Global Nuclear Fuel

Subject: GNF-A Safety Analysis Report Update for Model No. NPC Package

Attached is are revised pages to Chapter 6 – “Criticality Safety Evaluation” of the NPC Safety Analysis Report (SAR) which incorporate additional information regarding material classification.

Attachment: Revised Pages – Chapter 6 NPC Safety Analysis Report

Figure 6.0 K-infinite Comparison of U-compounds

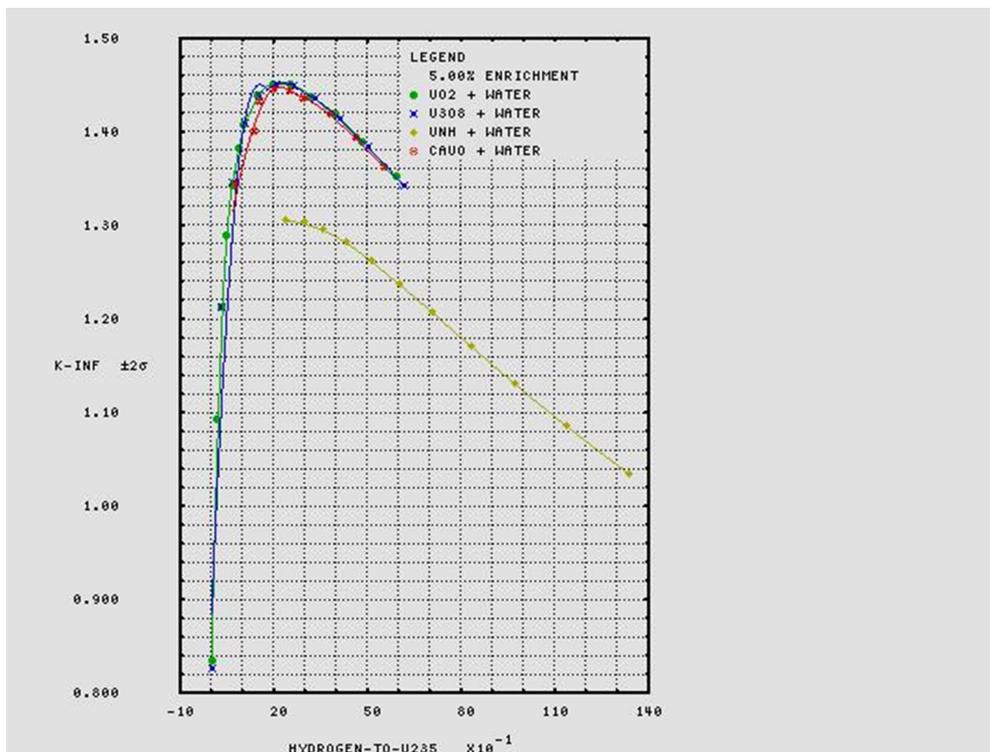
A reactivity comparison between 5% enriched theoretical UO_2 , U_3O_8 , UNH, and $CaU_6O_{19} \cdot 11H_2O$ compounds with water is provided in Figure 6.0 demonstrating that the theoretical mixture of UO_2 and water is conservative relative to other homogeneous uranium compounds. For k-infinite reactivity comparisons, refer Appendix 6.11 for a more complete material specification listing of uranium compounds evaluated.
